RE: Muskegon Community College  
Master Plan Review - Floor Structure Cracks  
JDH File 0912-015

**Re: Structural Investigation of Several Campus Buildings – Updated per Req. #6663**

SCHEMATIC OF "FIRST FLOOR FRAMING PLAN"  
(BETWEEN 2<sup>ND</sup> & 3<sup>RD</sup> FLOORS OF BUILDING)

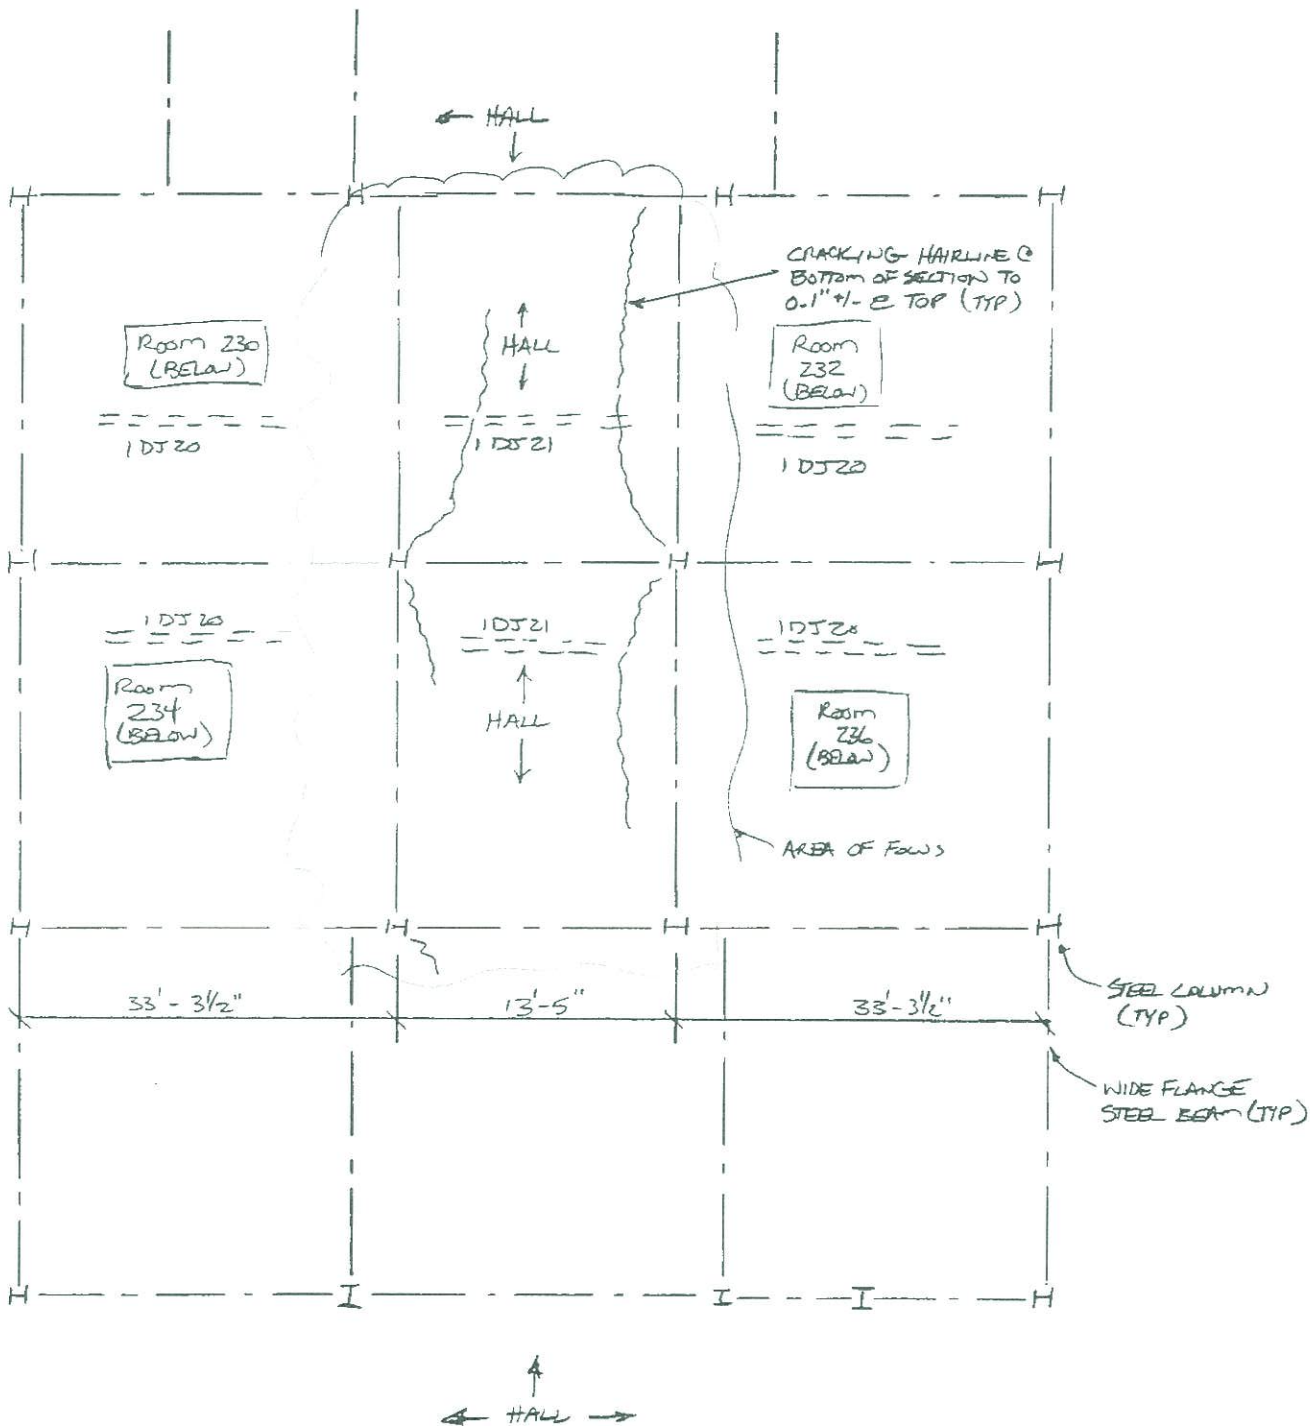
The first area of concern is in the classroom area of the main building. The 3<sup>rd</sup> floor concrete joists and flooring above the hallway adjoining Room 230 to 240 exhibit severe cracking. The main framing in this area consists of steel beams running parallel with the hallway located in the partition walls separating the hallway from the classroom areas. These beams are supported by steel columns, which carry the loads to the foundation. The steel beams, in turn, support a series of concrete joists and integral concrete floor. The concrete joists are oriented perpendicular to the hallway. We have attached a schematic of the area for your reference. The cracks are primarily located within 3 feet of the steel beams supporting the hallway and oriented parallel to the hallway. The cracks range from hairline cracking at the bottom of the concrete joists to approximately 0.1" or more in the floor slab. There is additional secondary cracking radiating from the main crack with concrete spalling. Based on a limited review of the surrounding area, the cracking observed appears to be concentrated in the hallway location.

We also considered flexure of the concrete joists under loading as a primary cause of the cracking and feel this to be the likely cause based on several factors. The first factor is the nature of the cracking itself. The cracks are predominantly oriented parallel to the steel support beams, which could indicate flexure. The cracking is generally located near the supports, which would be expected from high stresses due to negative moment bending near the supports in a continuous beam configuration. Cracking has opened to approximately 0.1" at the top of the section but has remained fairly tight at the bottom, which further supports the contention that the cracking is the result of high stresses over the supports.

The second factor considered is the design on the construction plans and possible misinterpretations by contractors. Sheet S13 shows the framing for the area in question. It indicates that the joists spanning the hallway area are to be a "1DJ21", which is a 5"x8" joist with integral 2-1/2" floor slab and a "1DJ20", which is a 6"x14" joist with integral 3" floor slab spanning the adjacent classrooms. For high stresses due to negative moment to be a primary cause of the cracking, the joists and flooring would have to be at least partially continuous at the support. Based on our review of the drawings it is possible that a contractor misunderstood whether the joists were to be constructed continuous over the support beam. First, the notes on sheet S5 indicate "concrete joists shall be spaced for continuous construction from bay to bay unless otherwise shown on the drawing". Under the "Remarks" column of the joist schedule on sheet S13, it indicates that the 1DJ21 joists are not to be continuous with the 1DJ20 joists. However, the construction joints at the support beam were specifically called out on the plans for Part C of the building, but the callout was omitted from the area in question in Part D. Also, the building is fairly symmetric in Part D, and the opposite area appears to be designed for continuous construction. Finally, the joist schedule calls for a #3 dowel bar, 3' long, to be placed across the construction joint at each joist, which would at least partially fix the joint and allow negative moment transmission. Based on these items, it is possible that the contractor misinterpreted the design intent and constructed 1DJ20 and 1DJ21 continuous and did not leave a break in the welded wire fabric reinforcement in the slab. Finally, the joist callouts appear to show the concrete joists parallel to the hallway as opposed to perpendicular, which appears to be the design intent and is how they were constructed. This could have caused further confusion during construction and possibly resulted in improper orientation of the welded wire fabric, which would further reduce the section's ability to resist negative moments.

Based on these two factors, we feel that enough negative moment was transmitted through the joints at the supports of the 1DJ21 joists to cause cracking of the section. Since the reinforcement in the floor slab is nominal welded wire fabric for temperature and shrinkage, the cracking has opened and propagated under loading. We also noted the welded wire fabric exposed in one of the cracks because it was placed with limited cover near the bottom of the floor slab. This lower position would reduce the fabric's effectiveness in resisting moments and allow wider growth of cracking.

Due to the severity of the cracking, we recommend that MCC consider a repair/retrofit to the area to prevent further damage to the structure and increase reliability. A retrofit could take the form of supplemental carbon fiber reinforcement applied to the top of the flooring, a supplemental steel system from the bottom of the section in conjunction with sealing of the cracking or another approach designed to reinforce the section. During our site visit, we marked and recorded crack widths in a number of areas. Because the timeline to budget, plan, design and construct repairs could be a lengthy one, we recommend that the cracking be monitored for further progression. We also recommend reviewing the corresponding area in Part "C" of the building, because it is similar in design.
